FPPA design

Dave Cockerill, 11 Feb, 2002

1. FPPA gain stages – are they appropriate?

Figure 1

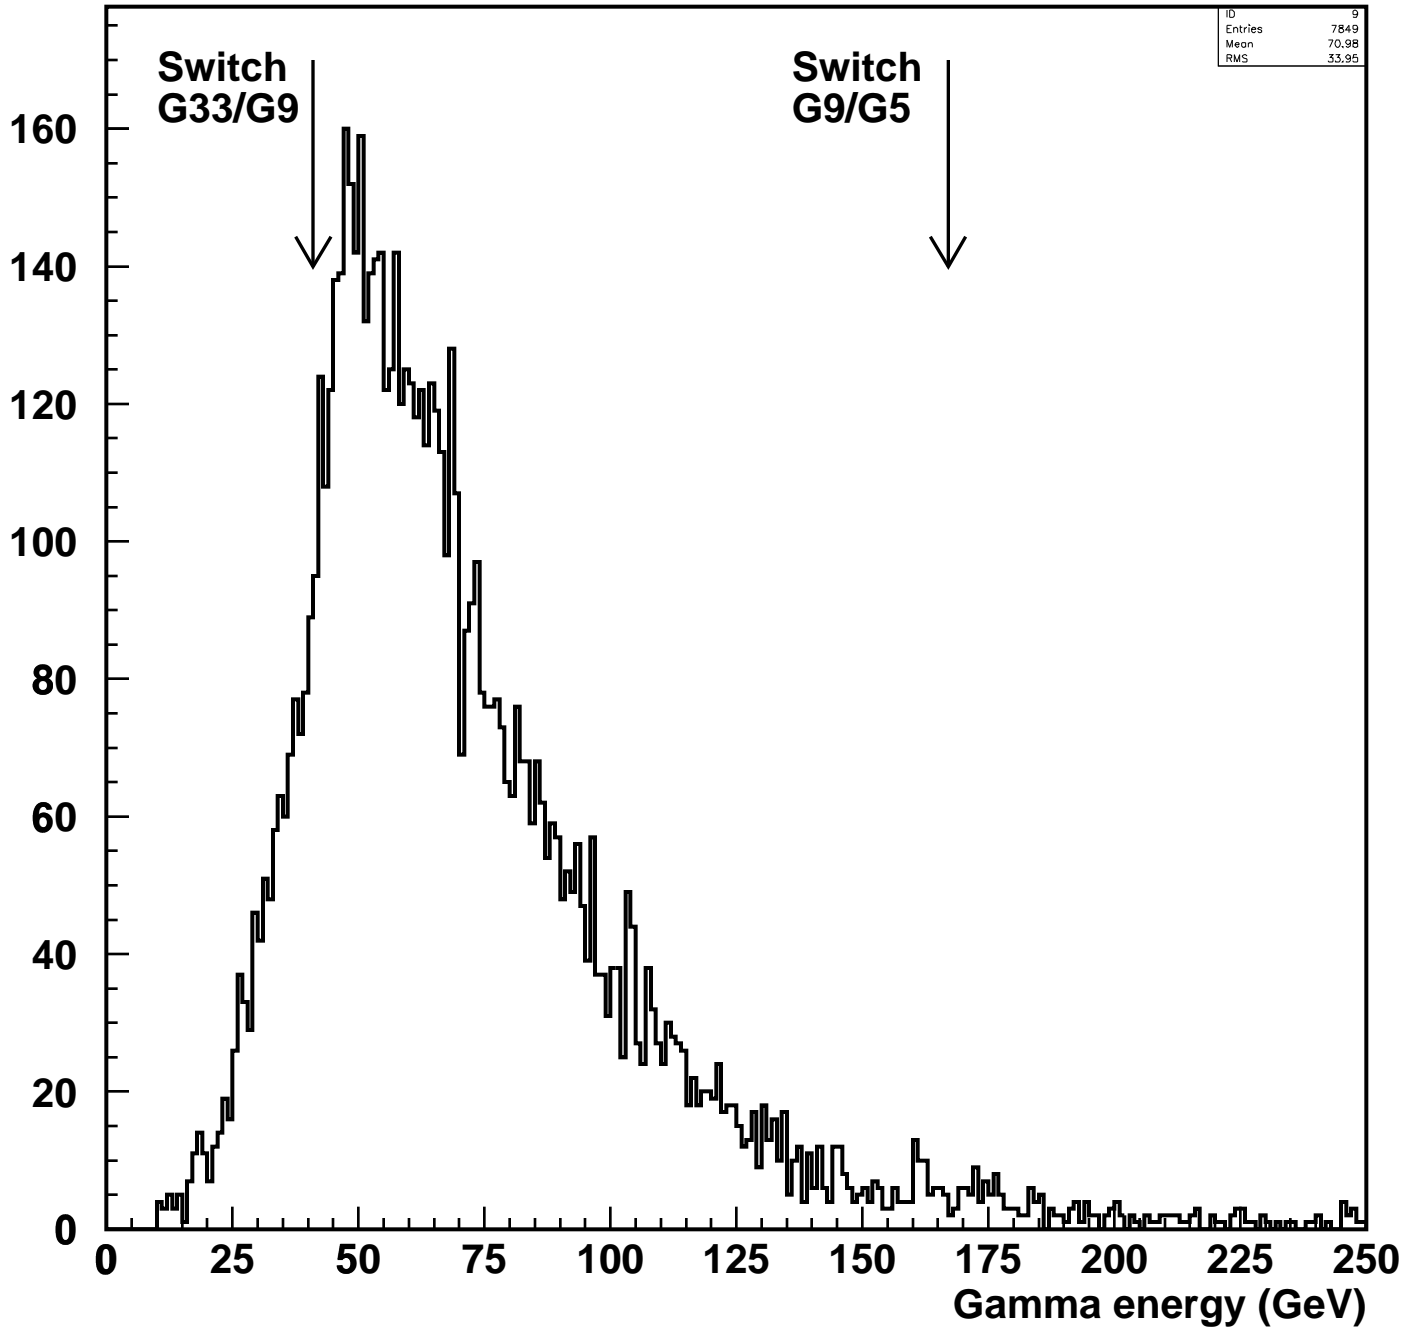
The barrel and endcap energy distributions for gammas which trigger CMS, from Higgs- $\gamma\gamma$ decays, are shown in figures 1 and 2, for $M_H=100$ GeV. The associated acceptance and P_T cuts are shown in figures 3 and 4. Electrons from Z decays (which would be used in calibration) will have a similar energy distribution.

Gain range x9 has a full scale range of 167/333 GeV which encompasses most of the gammas in Figures 1 and 2. Gain range x9 has a lsb of 82 MeV which is more appropriately matched to the EE noise per channel target of 150 MeV. The lsb is less well matched in the barrel case. This could be improved with a gain range of 12-15 instead of 9.

The switching points, from gain range x33 to x9, are shown by the arrows in figures 1 and 2. Relatively few photons are measured within gain range x33.

Benefit 1) From figures 1 and 2 it is clear that the peak digitization will almost always be on gain range x9. The other samplings of the pulse will certainly involve gain range x33. Thus it will **nearly always** be necessary to use a cross calibration from gain range x9 to gain range x33 for the struck crystal. This is an unwelcome degree of extra complexity, which the proposals would largely eliminate.

Proposal 1: Drop gain range x33 from the FPPA.

Proposal 2: Use only gain range x9 for high precision physics.
